## ADDENDUM

**ADDENDUM NO.:** 03

**PROJECT NAME:** Lake View High School Renovation Project

**DATE OF ISSUE:** May 1, 2017

1 FIRST FLOOR CONSTRUCTION REFERENCE PLAN-NORTH  
1/16" = 1'-0"

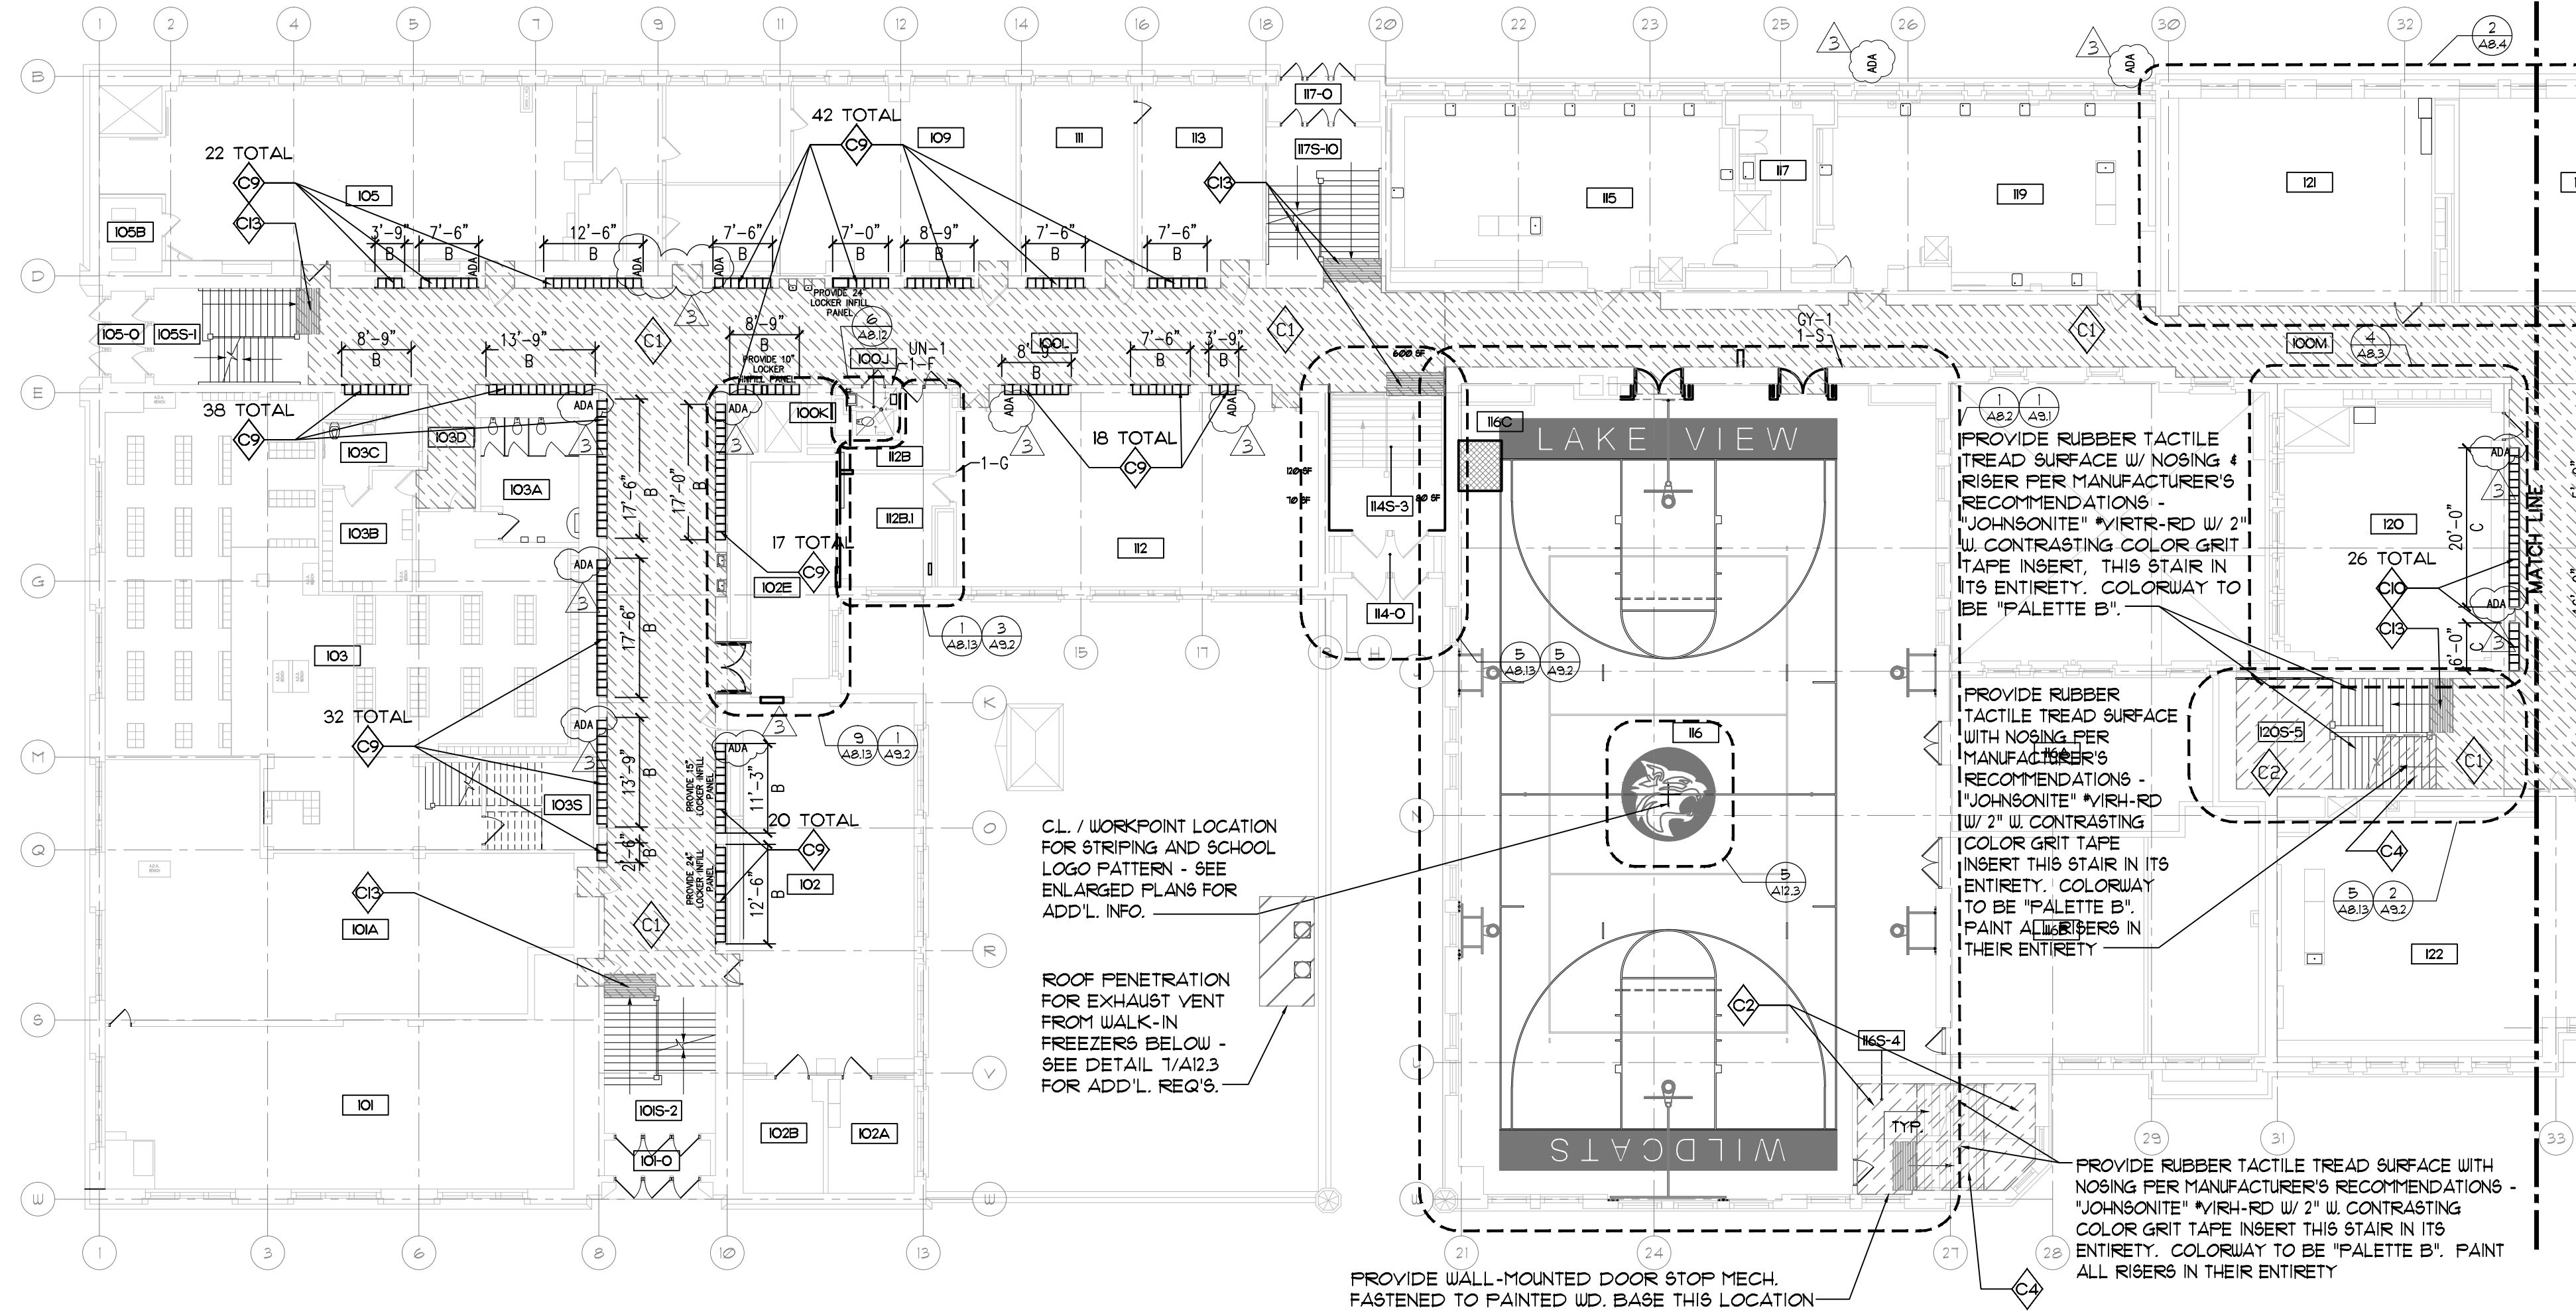
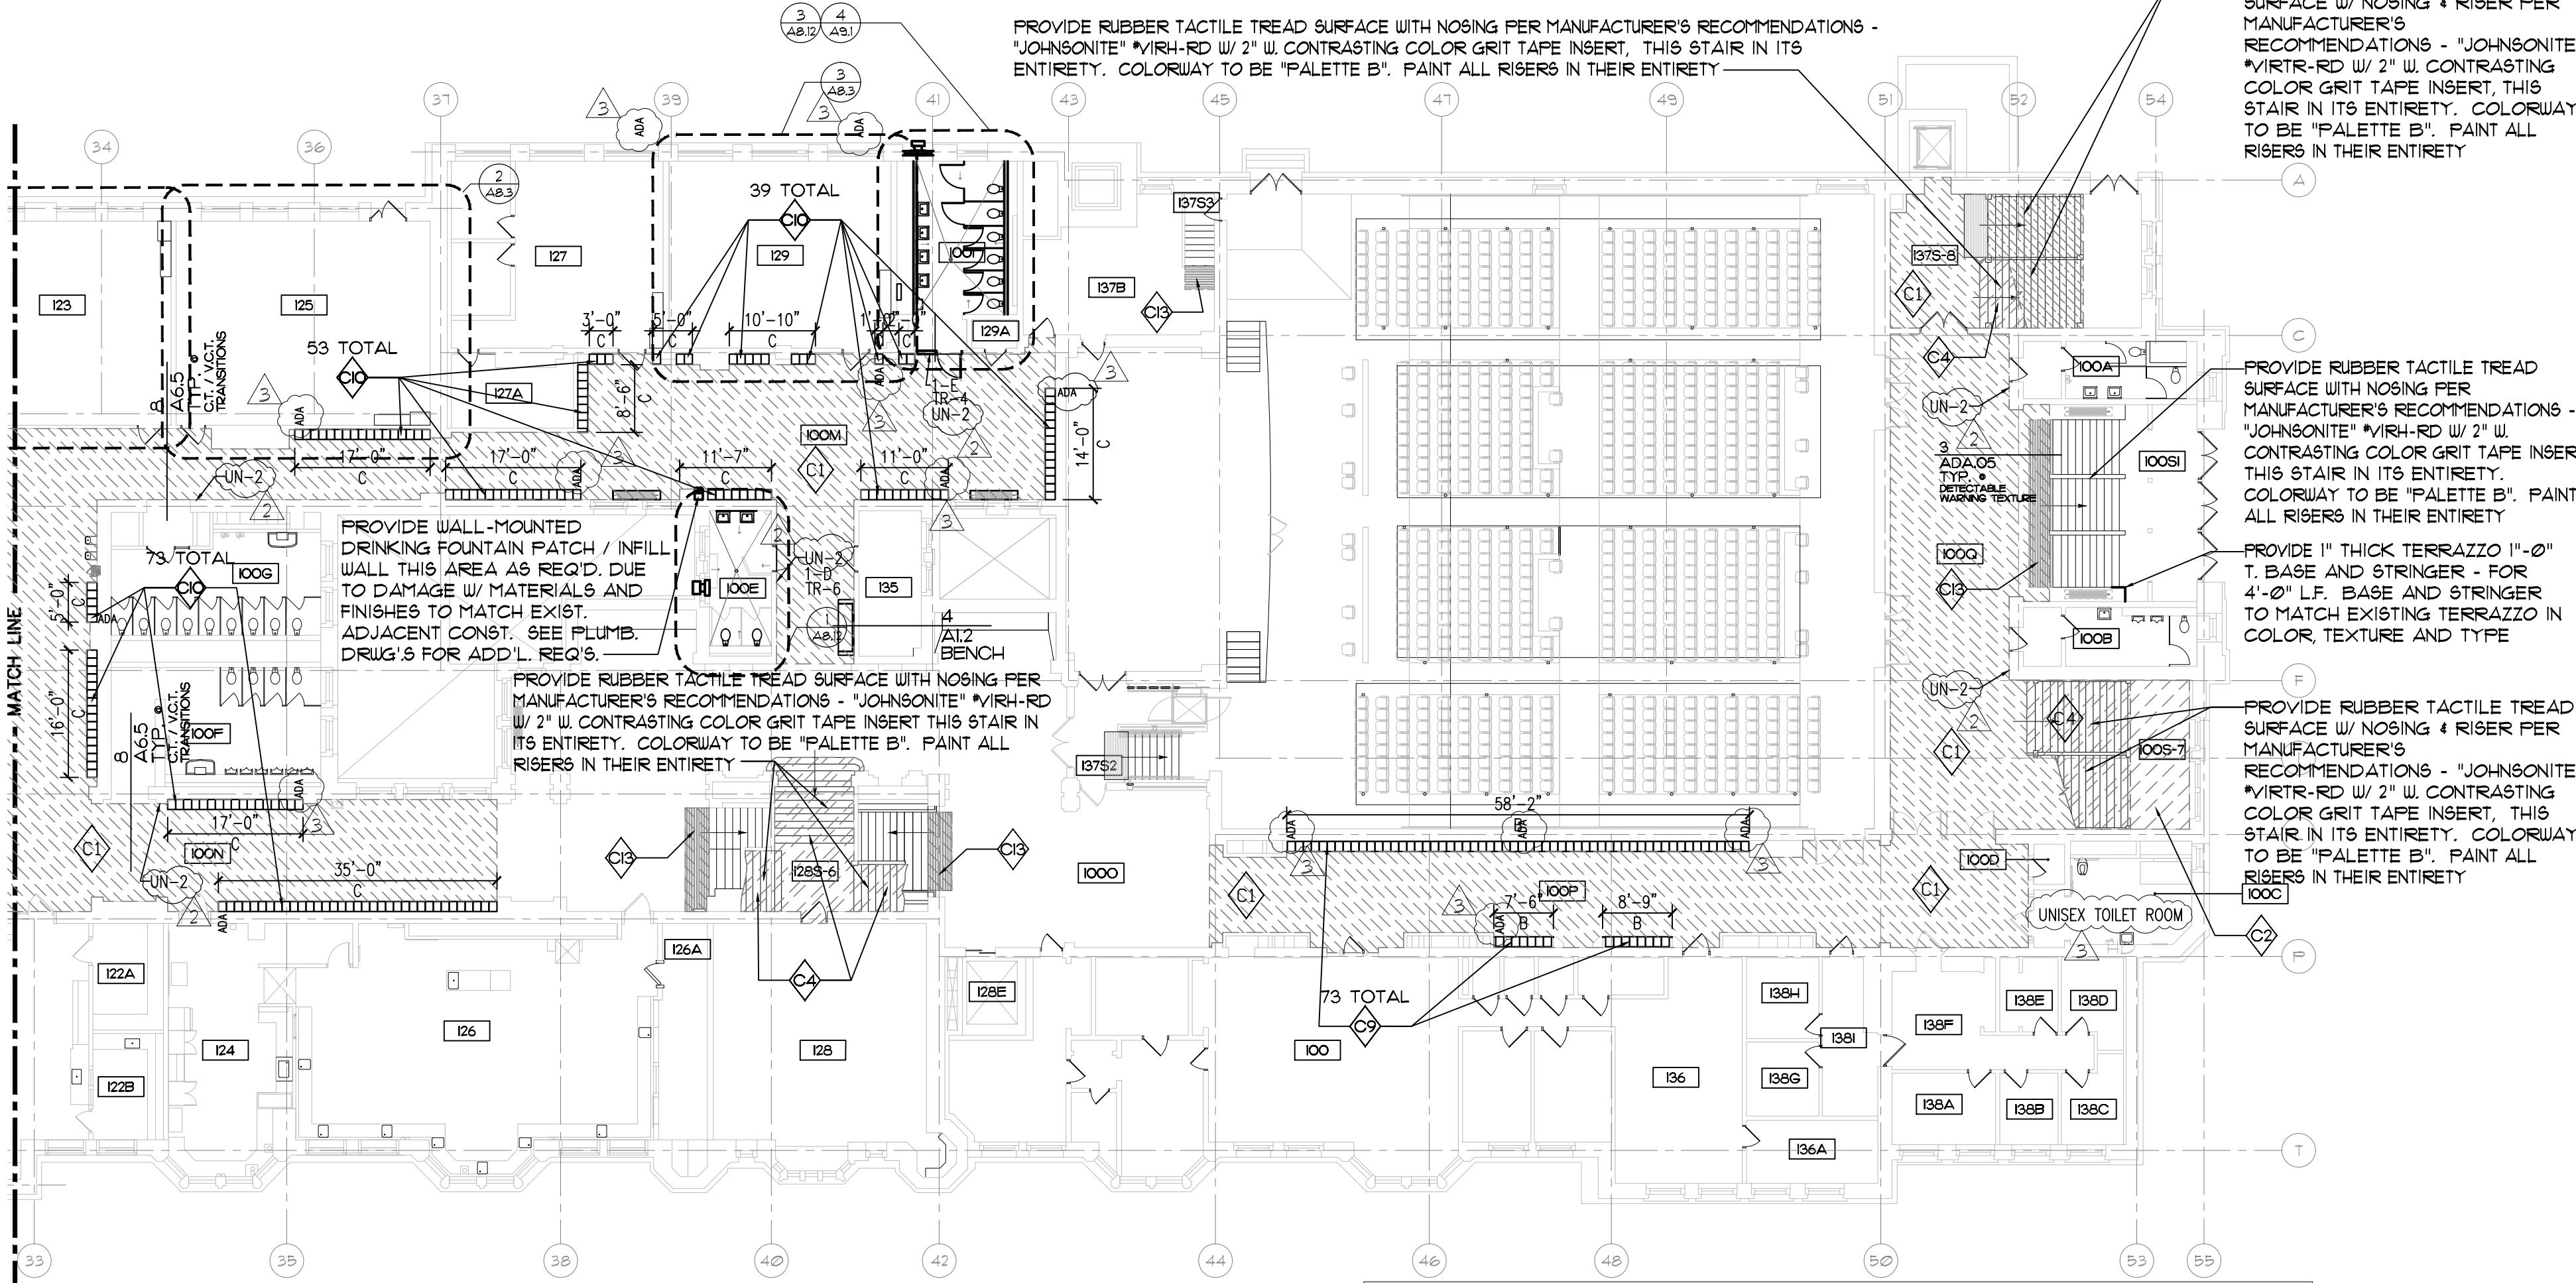
- REVISED** Drawing No. A6.1, FIRST FLOOR CONSTRUCTION REFERENCE PLANS; A6.2, SECOND FLOOR CONSTRUCTION REFERENCE PLANS; A6.3, THIRD FLOOR CONSTRUCTION REFERENCE PLANS and A6.4, FOURTH FLOOR CONSTRUCTION REFERENCE PLANS – Details 1 and 2: Locations of ADA lockers, ADA windows (previously indicated on exterior building elevation sheets A5.x series) and unisex toilets are shown.
